ADDENDUM NO. ONE

PROJECT TITLE: Shelter and Concrete Work at
Bicycle Safety Town

ISSUANCE DATE: March 29, 2012

ADDENDUM #1

1
A1
1"=10'
Conc. Slab Dimensions

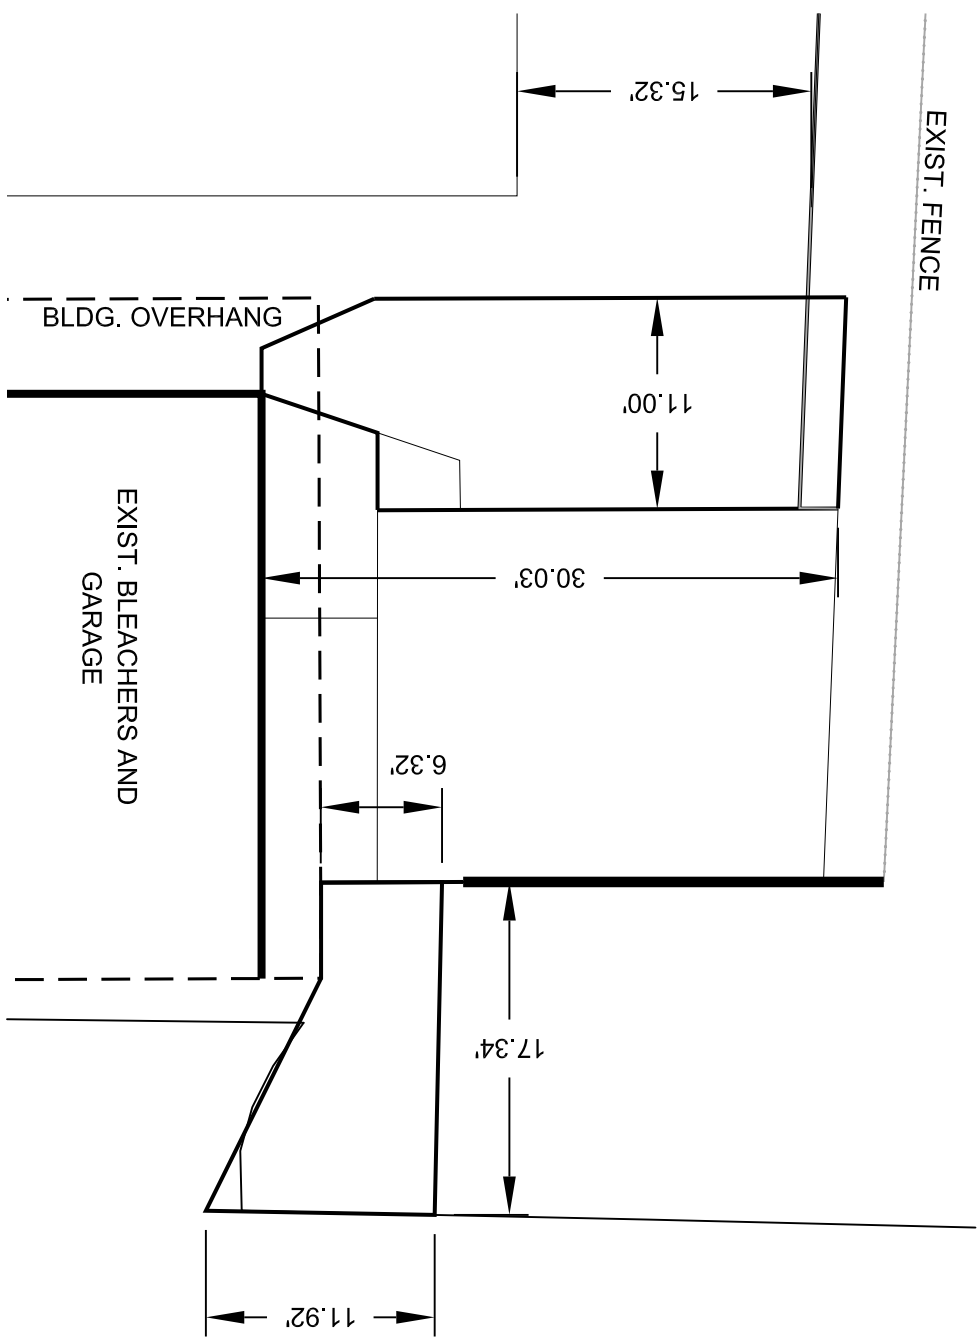
Sheets 2&3: Please see attached details for changes in concrete slab dimensions around garage based on field measurements.

Delete ramp "concrete access ramp" into playground shown on Sheets 2&3.

1 Accessible Ramp
 A2 NOT TO SCALE

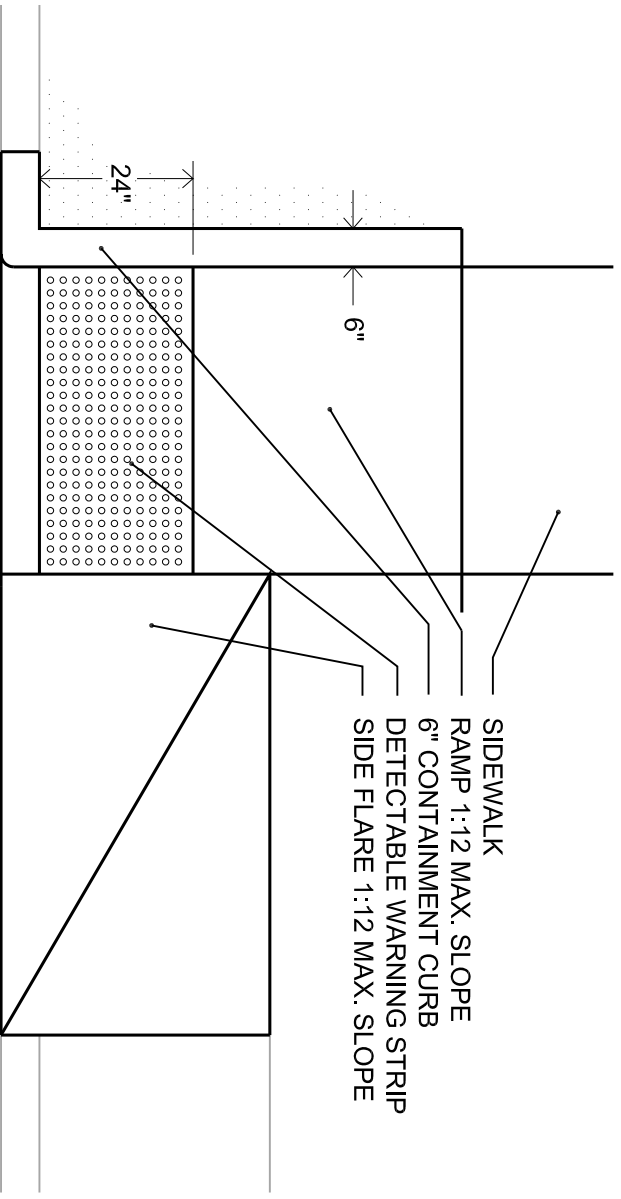
An additional detail for the accessible ramp to the shelter has been included for clarification.
